U.S. Department  
of Transportation  
**Federal Highway  
Administration**

February 8, 2002

Refer to: HSA-10/WZ-108

Thank you for your letter of January 9, 2002, requesting Federal Highway Administration (FHWA) acceptance of your company's portable sign stands and barricades as crashworthy traffic control devices for use in work zones on the National Highway System (NHS). Accompanying your letter was a report of the crash testing conducted by Karco Engineering and a video of the tests. You also asked for our review of the results of tests 1, 2, 3, and 5 that accompanied your July 9, 2001, letter (as you requested at the time we limited our review to the Little Buster stand, the subject of test 4.) You requested that we find these devices acceptable for use on the NHS under the provisions of National Cooperative Highway Research Program (NCHRP) Report 350 "Recommended Procedures for the Safety Performance Evaluation of Highway Features."

Figure 1. - Rubber Pole Base with 40 lb. Ballast, Thirty-six Inch by Thirty-six Inch Aluminum Sign, and Light.

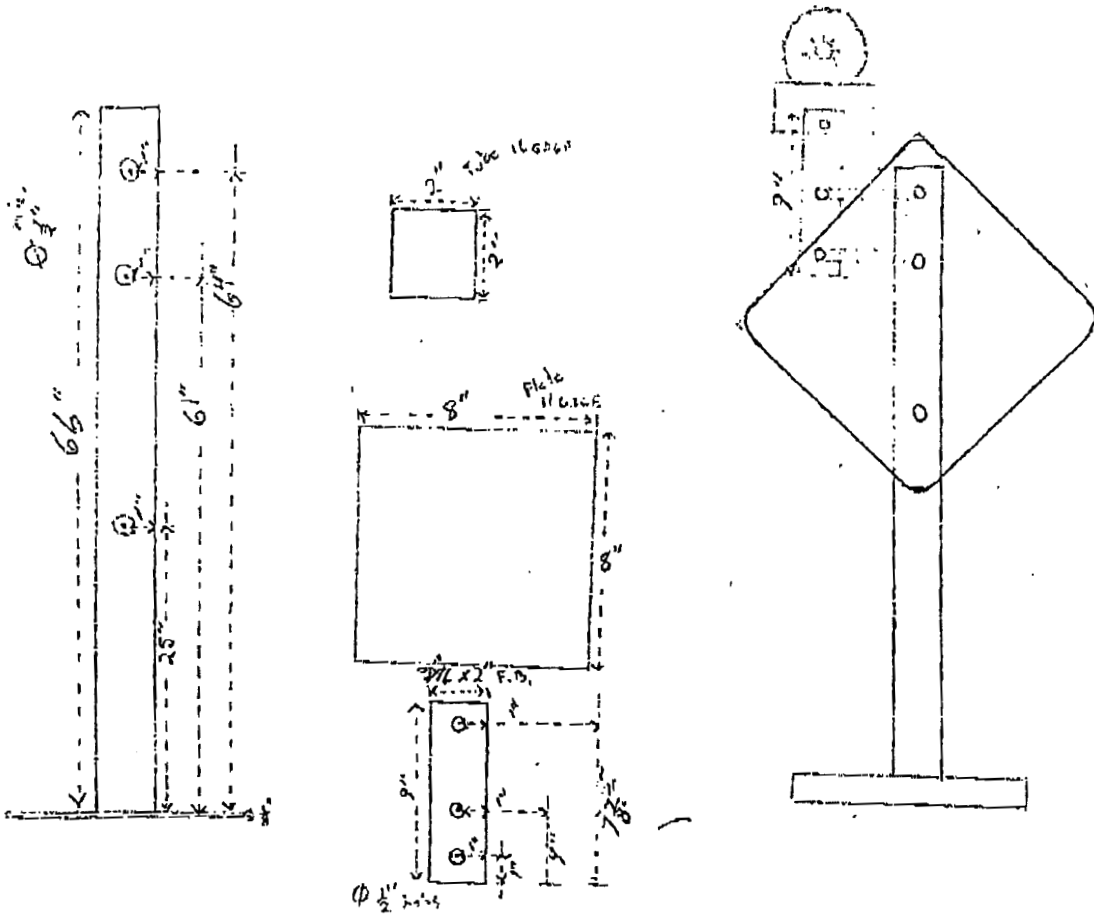
Windshield damage in Test 1 was primarily due to the flat impact of the warning light. A small but dense area of cracking was surrounded by more moderated spider web cracking. A driver should be able to see around the opaque area.

**Test 1. Sign Stand. Rubber Pole Base with 30 pound ballast, 36 x 36 inch aluminum sign, and light.** Acceptable, but marginal

Figure 2. – Big Buster Sign Stand with Forty-eight Inch by Forty Eight Inch Aluminum Sign, Aluminum Inner Mast, and Plastic Flag Holder; Sign Height Sixty-six Inches Above Ground.

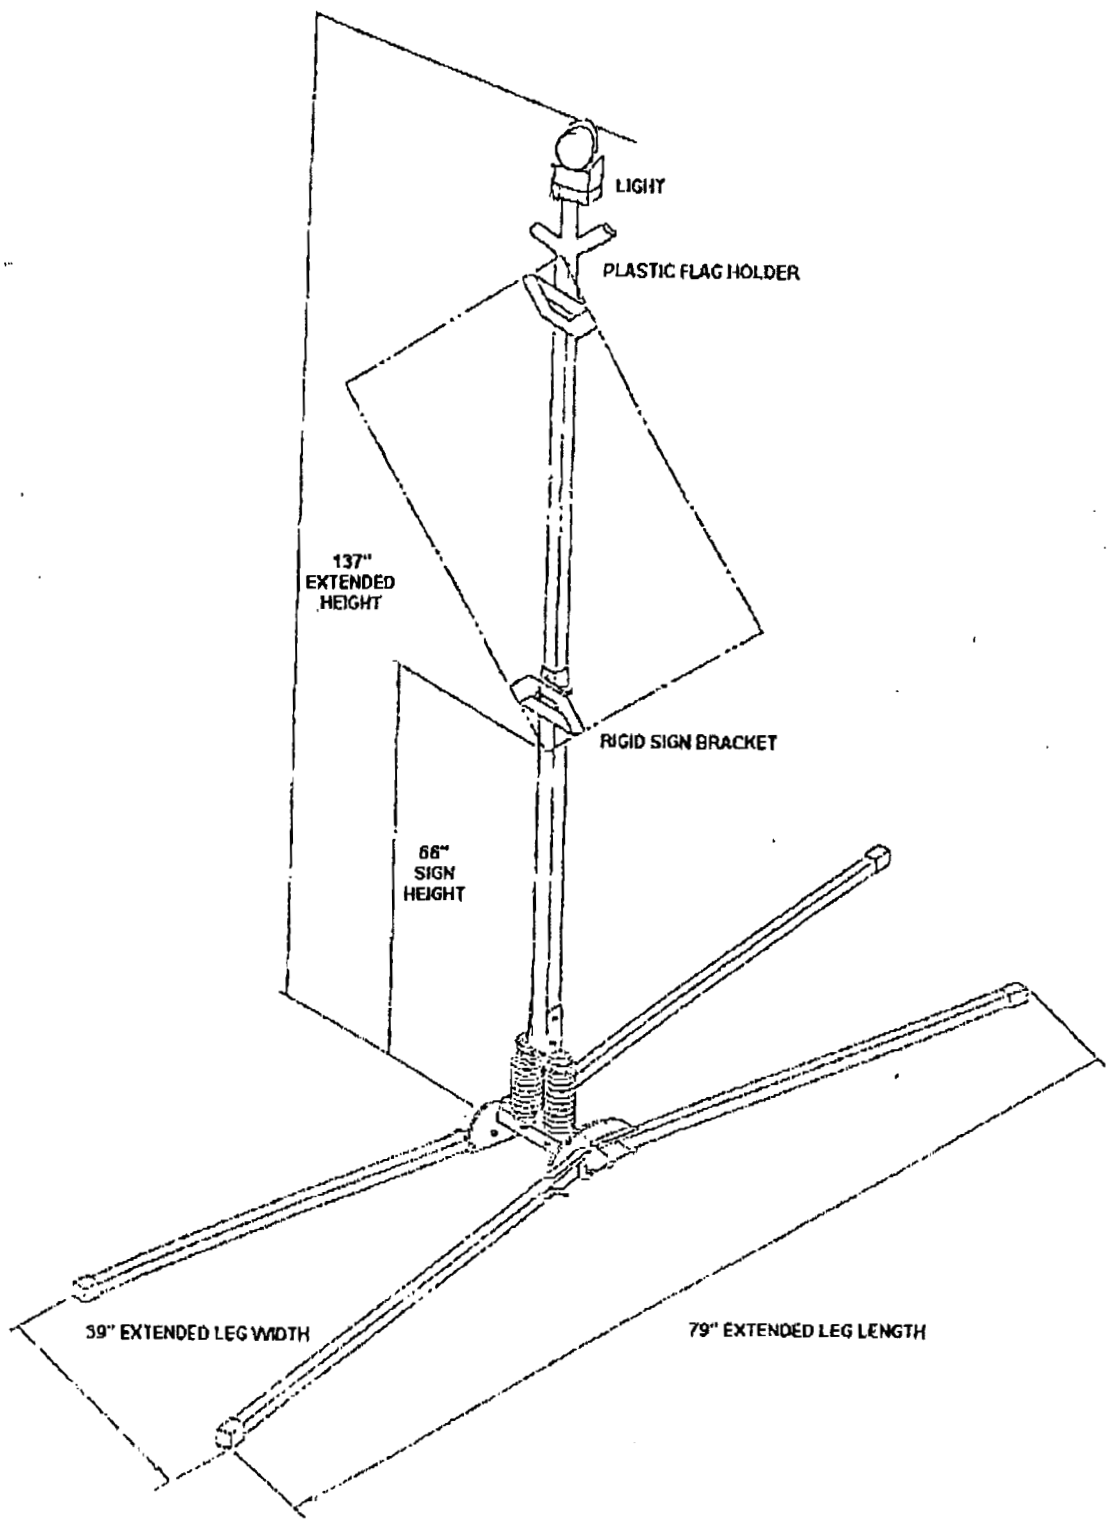
Windshield damage in Test 2 was due to the impact of the sign's mast contacting the roof line. Moderate cracking radiated from this impact point.

**Test 2. Big Buster Sign Stand with 48 x 48 inch aluminum sign.** Acceptable

Figure 1. – Little Buster Sign Stand with Forty-eight Inch by Forty-eight Inch Aluminum Sign with Slip-over Tube Mast; Sign Height Eighteen Inches Above Ground.

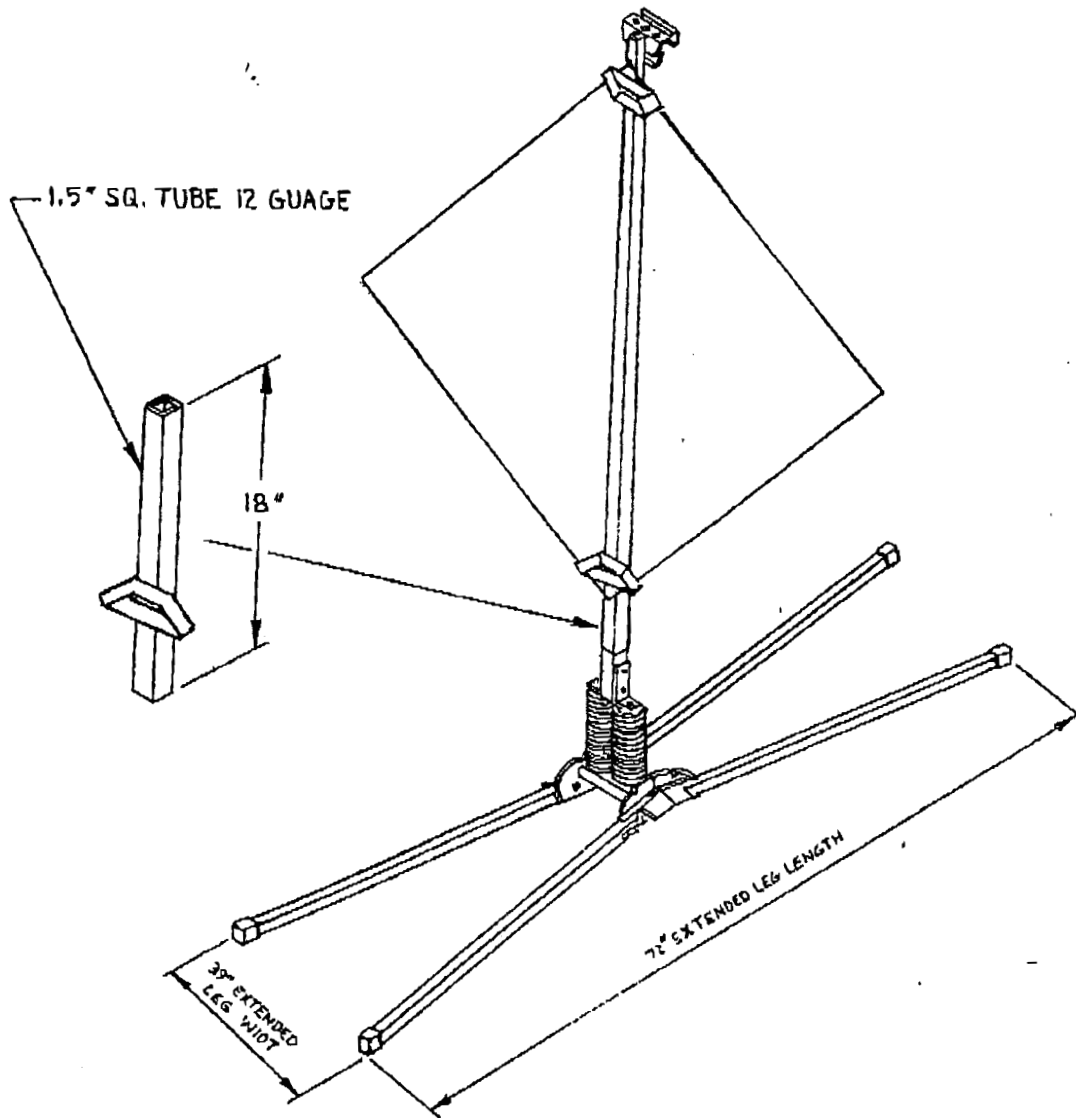
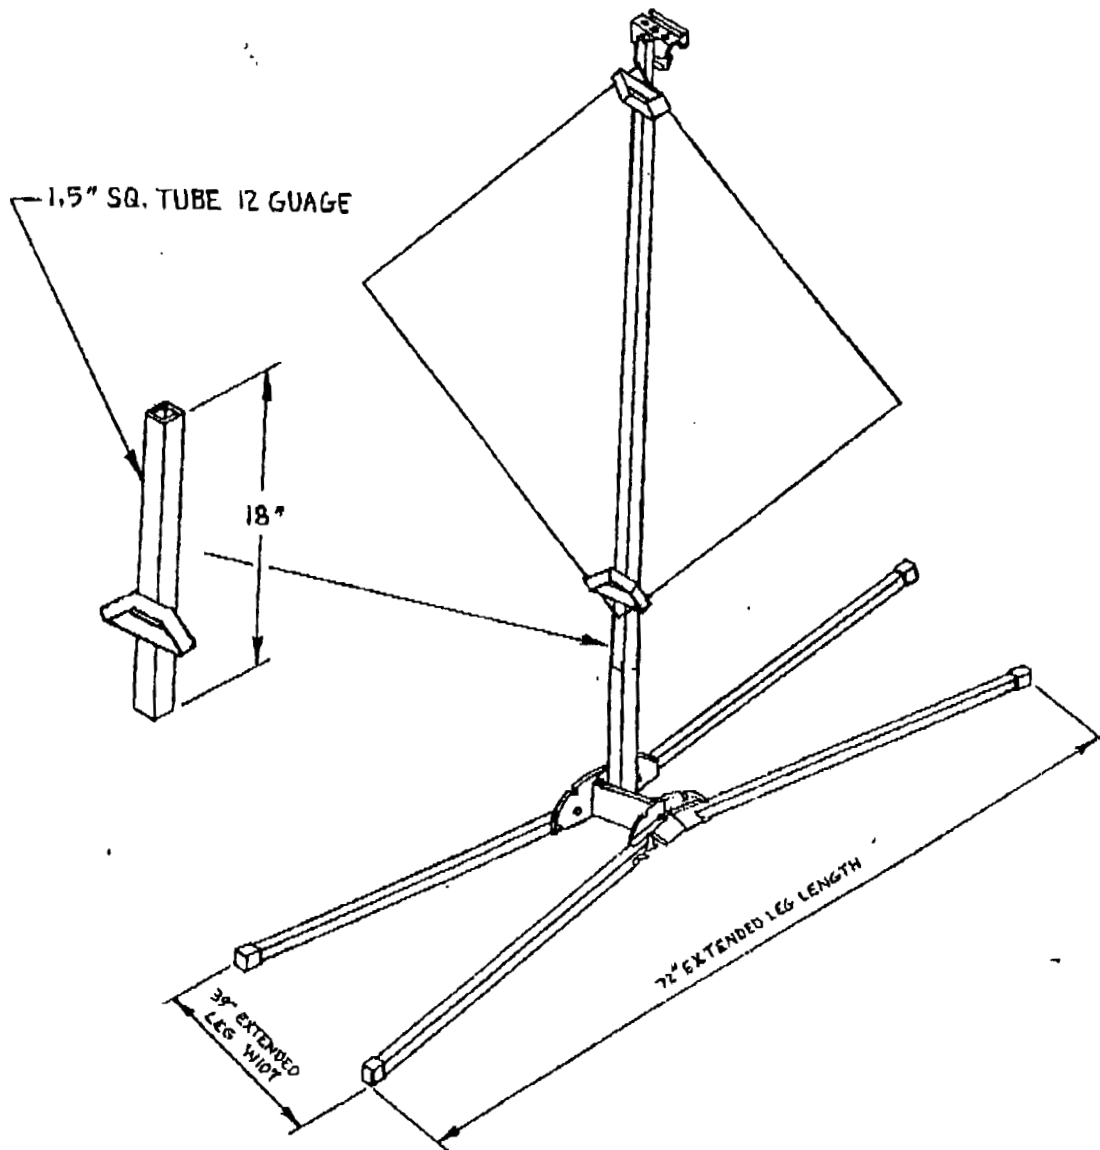
Windshield damage in Tests 1 and 3 resulted from the flat impact of the aluminum sign panel in the head-on test. Cracking was distributed over the whole windshields of both cars but did not significantly impair the driver's ability to see. Deflection of the glass was between two and three inches. Therefore, this device will be considered marginally acceptable.

**Test 1. Little Buster Sign Stand with 48 x 48 inch aluminum sign with Slip-over Tube Mast.** Acceptable, but marginal

**Test 3. Econo Buster Sign Stand with 48 x 48 inch aluminum sign with Slip-over Outer Tube Mast.** Acceptable, but marginal

Figure 2. - Type 3 Plastic Barricade with Plastic Posts and Pinned Rubber Bases, Forty-eight Inch by Forty-eight Inch Corrugated Plastic Sign; Sign Height Twelve Inches Above Ground.

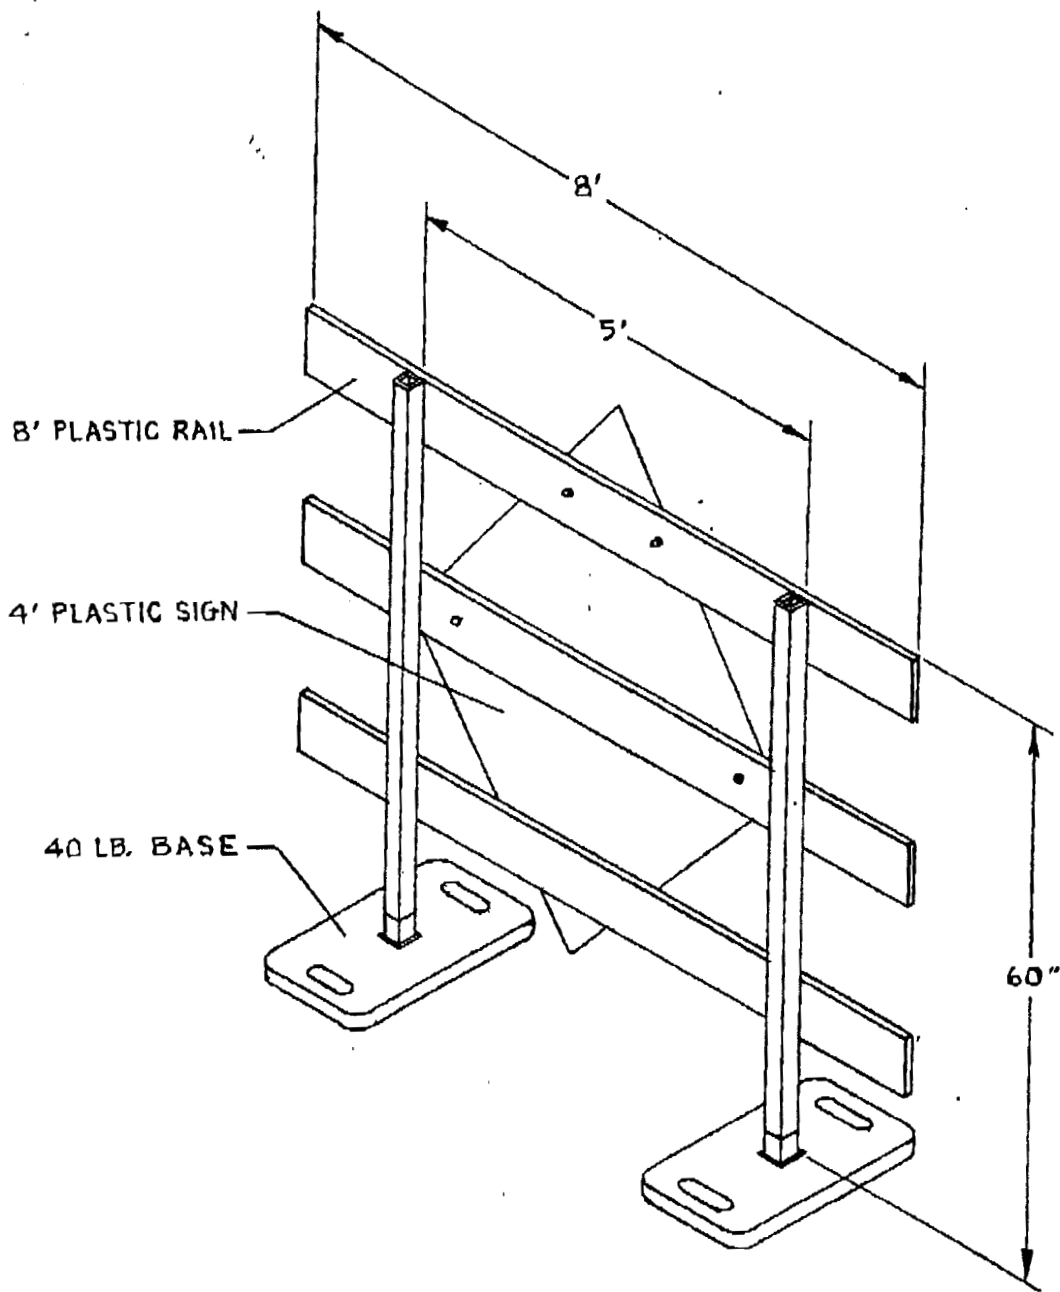
Test 2 was of a plastic framed Type III barricade. The vertical supports of this barricade shattered upon impact, allowing the horizontal rails to strike the windshield in both the head on and 90 degree tests. Although there was no windshield penetration in this case, the potential for rigid horizontal panels to spear the vehicle is higher. It is critical, therefore, that this design use flexible, lightweight horizontal rails as tested. The corrugated plastic sign panel mounted on the barricade is acceptable for use as tested.

**Test 2. Type III Plastic Barricade with Plastic Posts and Pinned Rubber Bases, carrying a 48 x 48 inch diamond sign.** Acceptable, but marginal

Figure 4. — Type 3 Plastic Barricade with Steel Post Uprights with Lights, Forty-eight Inch by Forty-eight Inch Aluminum Sign; Sign Height Twelve Inches Above Ground.

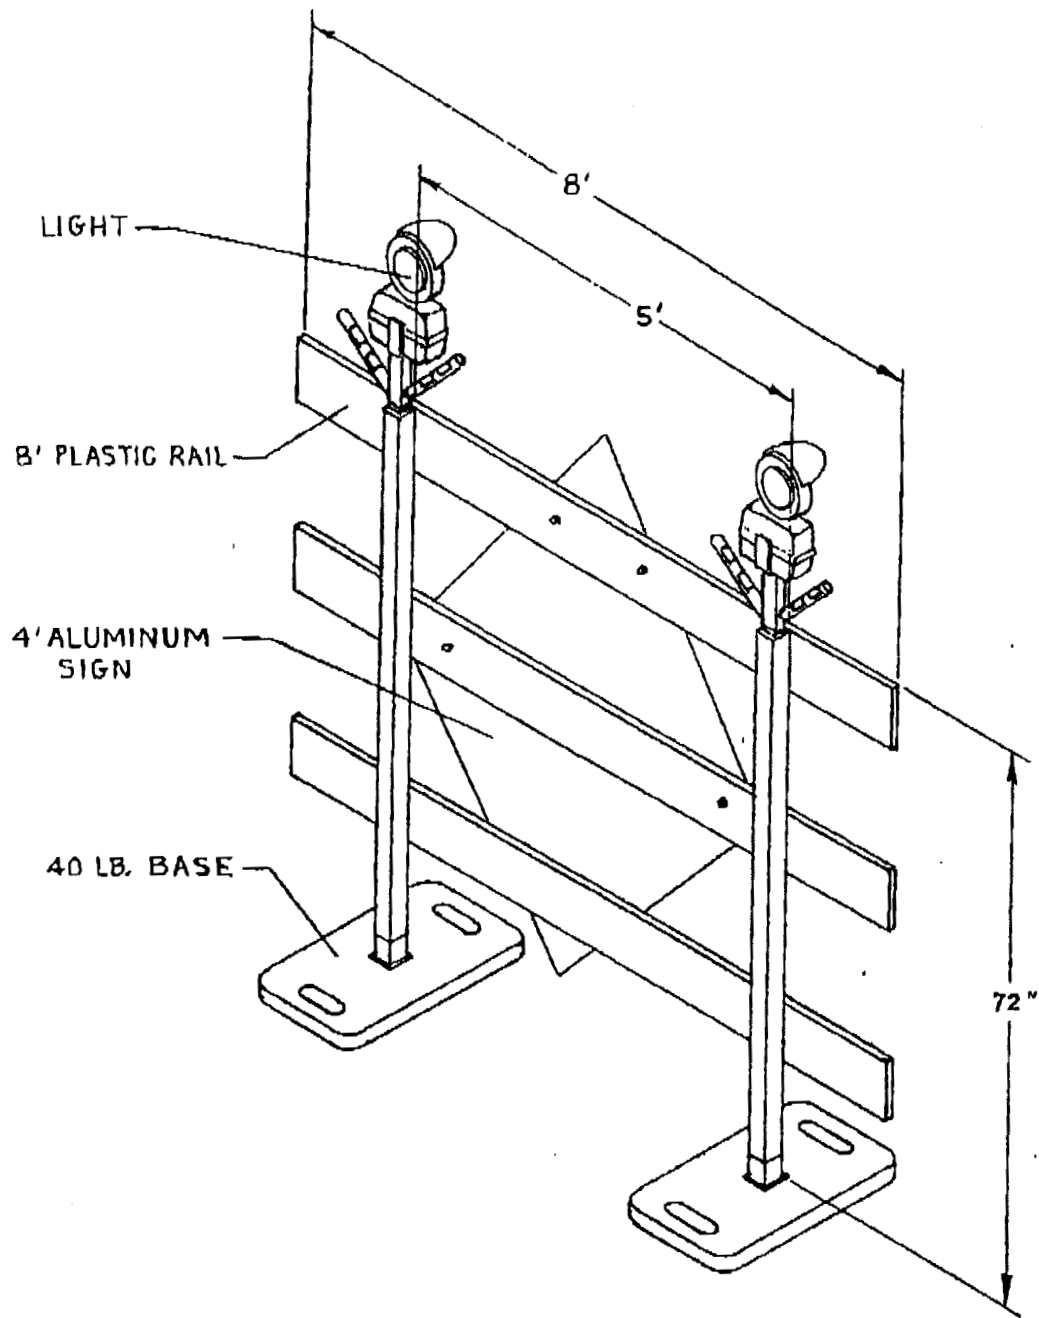
Windshield damage in Test 4 also resulted from the flat impact of the sign panel mounted to the barricade. The light gage steel vertical supports crumpled upon impact. The performance of these vertical supports was better than the plastic supports in Test 2, but did not hold the barricade together as well as the hot-rolled, high carbon steel angles, nor the perforated square steel tubes used in the generic Type III barricade designs distributed by the FHWA in our letter WZ-85. Even though the results of this test were acceptable, FHWA discourages the use of rigid aluminum or plywood sign panels centered on Type III barricades. We prefer that lightweight plastic sign substrates be used in this location, such as the sign in Test 2.

**Tube 4. Type III Plastic panel Barricade with Steel Post uprights and Lights, tested with 48 x 48 inch aluminum sign.** Acceptable with lightweight plastic sign panel
